**EPA comments on the Background Investigation Sampling and Analysis Plan
Columbia Falls Aluminum Company Superfund Site, Columbia Falls, Montana
Prepared for Columbia Falls Aluminum Company, LLC
Prepared by Roux Environmental Engineering and Geology, D.P.C.
Dated May 25, 2018**

**Responses Prepared for Columbia Falls Aluminum Company, LLC prepared by Roux
Dated July 9, 2018
Roux responses in blue**

Exhibit A. Illustration of Proposed Site vs. Background Comparison Approach for Soil

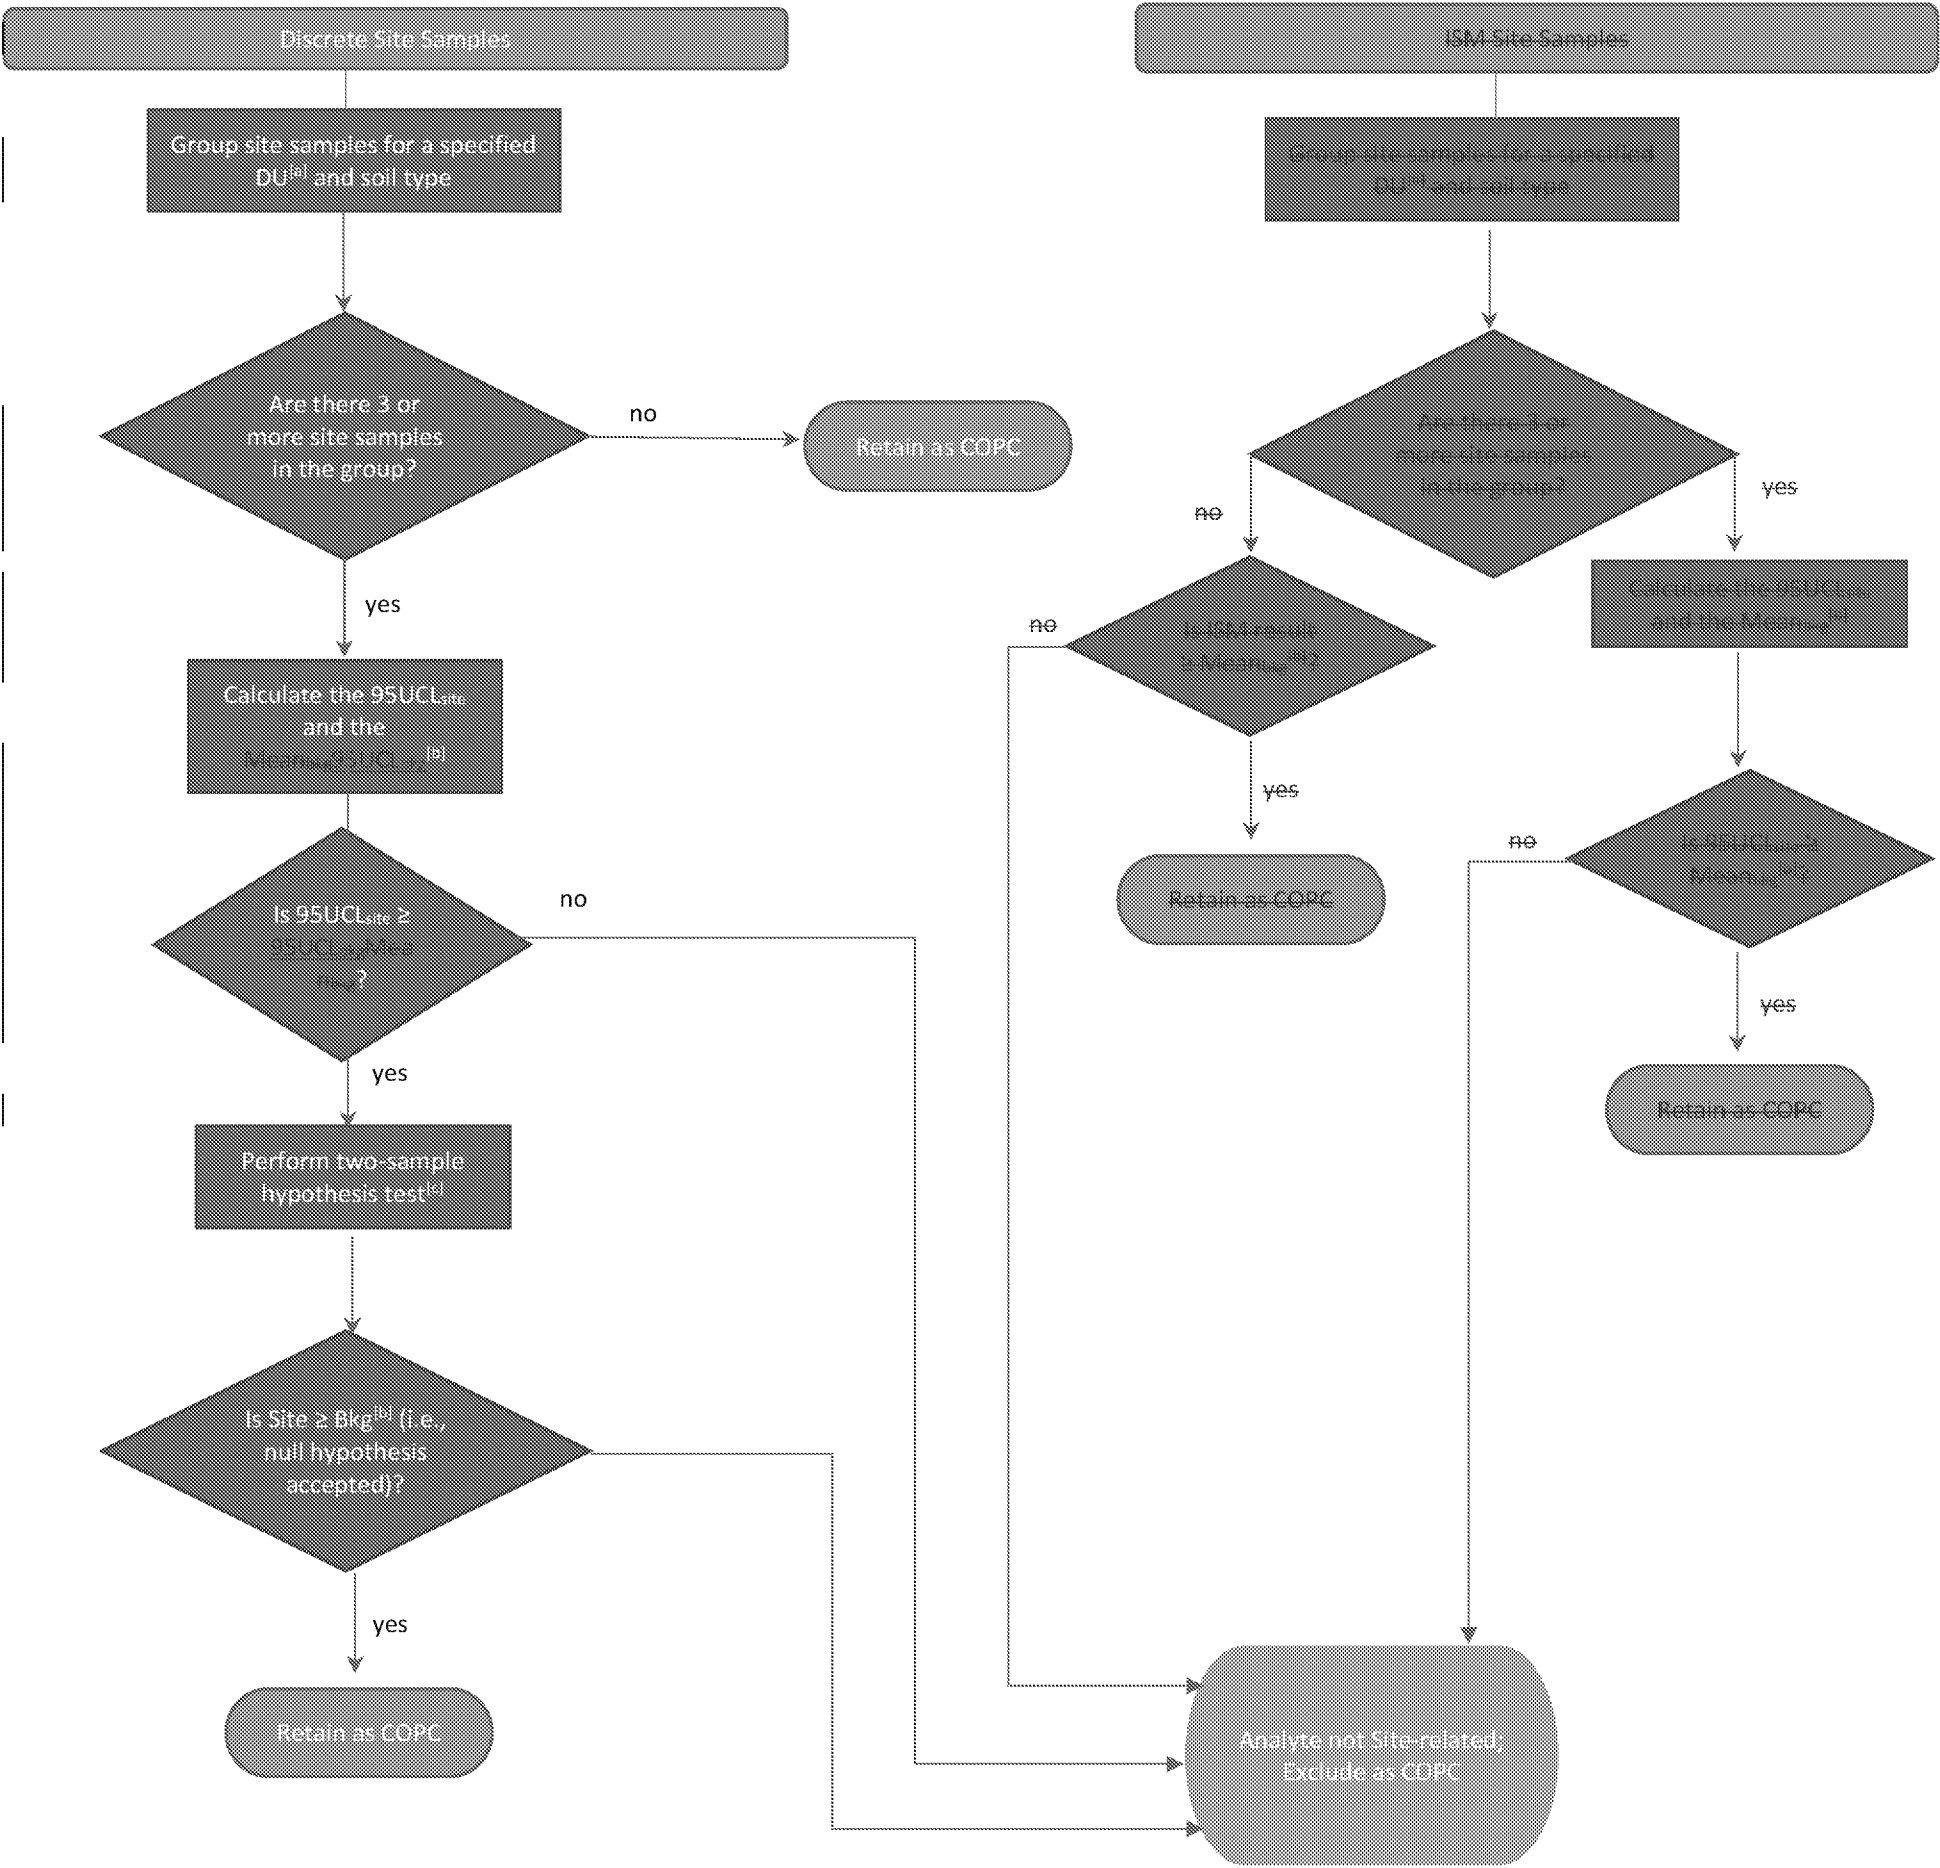
Page 3, Section 2.2 – This section does not discuss the statistic of interest for performing comparisons to background – i.e., a mean or a high-end value within the distribution. Although the text mentions the use of 95% upper confidence limits on the mean (95UCLs) and use of hypothesis testing (which is typically comparing means/medians), there is also mention of the use of background threshold values (BTVs) (which are often based on the high end of the background distribution). Thus, the basis for decision-making is unclear. Please revise the section for clarity; see also the proposed evaluation approach presented in Exhibit A.

Pages 5 and 6, Section 2.5 – Use of statistical hypothesis testing requires the two datasets are collected using similar methodology (i.e., cannot compare discrete grabs to ISMs) and has limited utility for samples collected via judgmental sampling. There is also no discussion of the use of the BTV in decision-making. This section should be revised to clarify the proposed methodology for making site vs. background comparisons for each sample type. Refer to the flow diagram in Exhibit A to illustrate EPA’s proposed methodology.

CFAC/Roux generally agree with the proposed Exhibit A flow chart and will incorporate the flow chart into the revised SAP. With respect to comparison of like statistics, the flow chart has been modified to be based upon comparison of the $95UCL_{site}$ and $95UCL_{background}$. While EPA's approach is more conservative, it mixes an upper confidence limit estimate of the mean with an arithmetic estimate of the mean. It would be more appropriate to make the comparison based on like statistics that consider the potential variability in the estimate of the "true" mean for site and background datasets. In addition, we have modified the footnote regarding outliers to be consistent with the response to comment regarding Page 5, Section 2.5. The modified flow chart is provided below in tracked changes.

Notes:
[a] DU is based on exposure area for each receptor
[b] Outliers will should be excluded from background dataset prior to calculations/hypothesis unless there a
location-specific reason identified for retaining testing
[c] Background Test, Form 2 at $\alpha = 0.10$
